民航局 AD 編號 AD number	CAA-2023-06-006	發布日期 Date issued	2023/6/28												
適用之航空產品 Applied to (models, serial numbers or part numbers, as applicable)	This AD applies to all The Boeing Company Model 747 – 100, 747 – 100B, 747 – 100B SUD, 747 – 200B, 747 – 200C, 747 – 200F, 747 – 300, 747 – 400, 747 – 400D, and 747 – 400F series airplanes, certificated in any category.														
主旨摘要 Subject	This AD requires revising the limitations section of the existing AFM to incorporate limitations requiring specific operating procedures, and retains the operating procedures for takeoff, ILS approaches, non-precision approaches, and go-around and mi														
民航局 CAA <input type="checkbox"/> 本國產品 Native product <input type="checkbox"/> 其他個案 Other	<div style="text-align: center;">設計國民航主管機構 Original Authority</div>

[Docket No. FAA–2023–0922; Project Identifier AD–2022–01431–T; Amendment 39–22472; AD 2023–12–14]

Airworthiness Directives; The Boeing Company Airplanes

2023–12–14 The Boeing Company: Amendment 39–22472; Docket No. FAA–2023–0922; Project Identifier AD–2022–01431–T.

Figure 1 to paragraph (g)(2)(i)— *Fundamental Effective Isotropic PSD at Outside Interface of Aircraft Antenna*

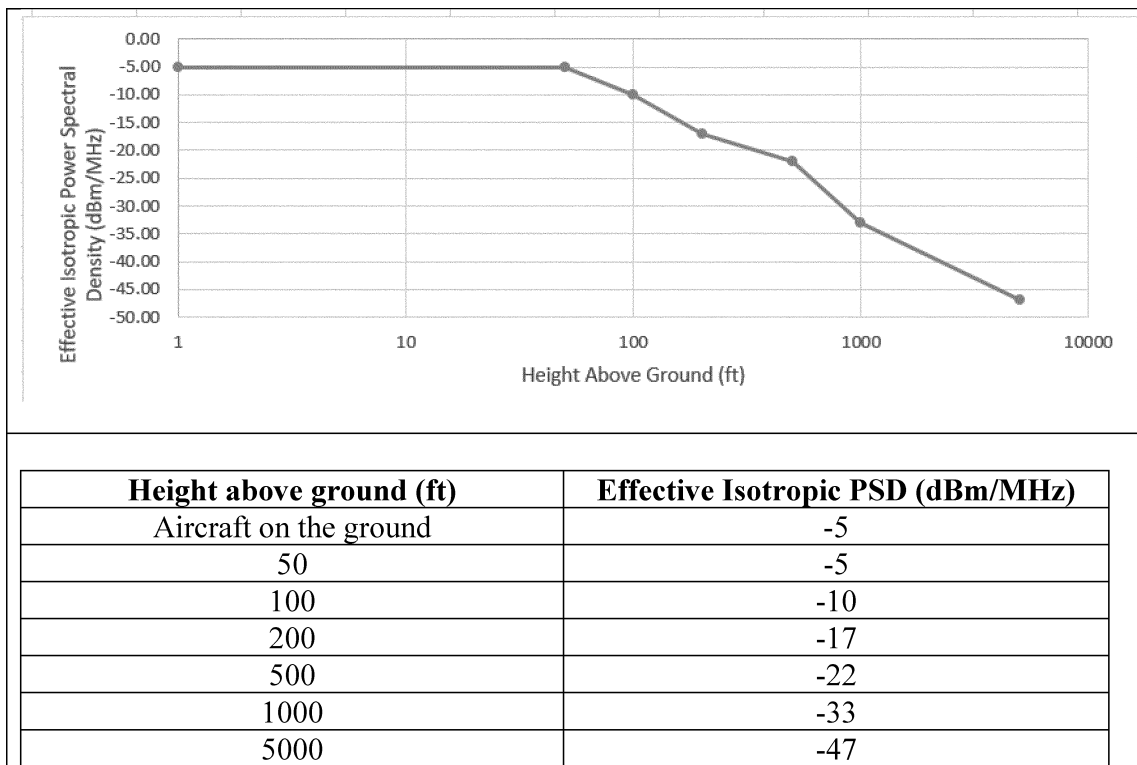
(i) Tolerance to radio altimeter interference, for the fundamental emissions (3.7–3.98 GHz), at or above the power spectral density (PSD) curve threshold specified in figure 1 to paragraph (g)(2)(i) of this AD.

Figure 2 to paragraph (g)(2)(ii)— *Spurious Effective Isotropic PSD at Outside Interface of Aircraft Antenna*

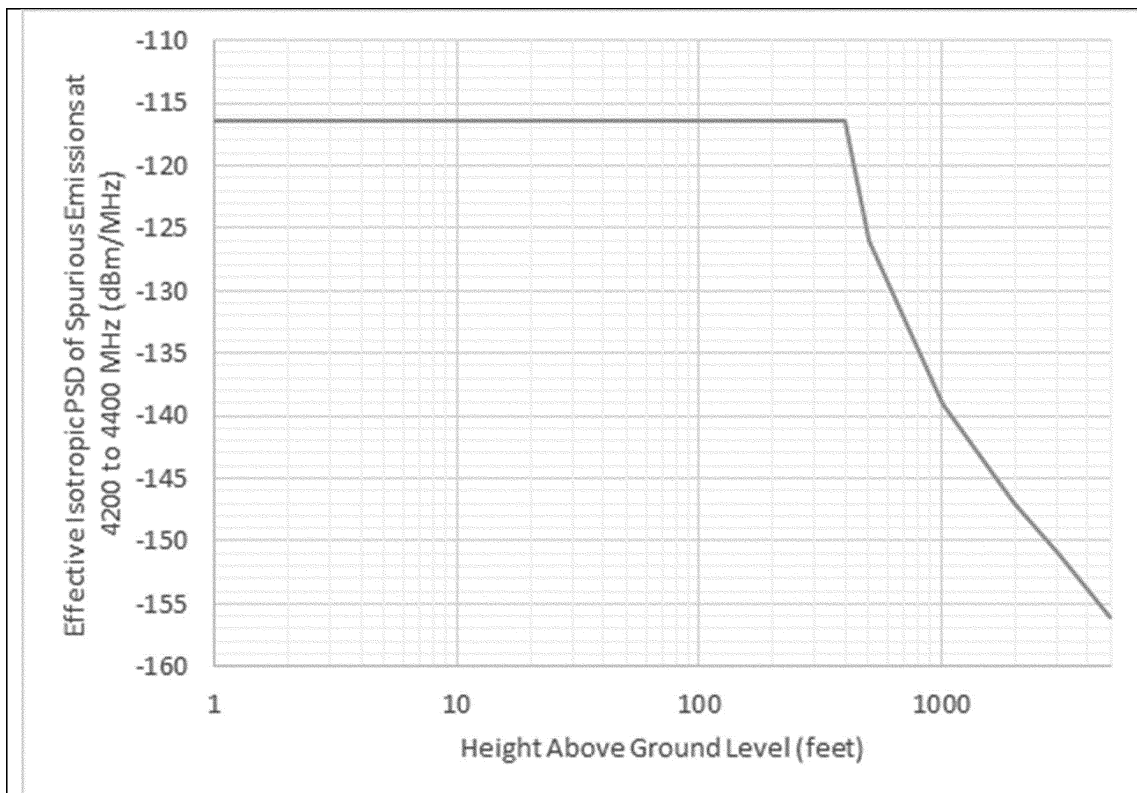
(ii) Tolerance to radio altimeter interference, for the spurious emissions (3.7–3.98 GHz), at or above the PSD curve threshold specified in figure 2 to paragraph (g)(2)(ii) of this AD.

<u>Aircraft Altitude (ft AGL)</u>	<u>Effective Isotropic PSD (dBm/MHz)</u>
1	-116.50
400	-116.50
500	-126.00
1000	-139.00
2000	-147.00
3000	-151.00
5000	-156.00
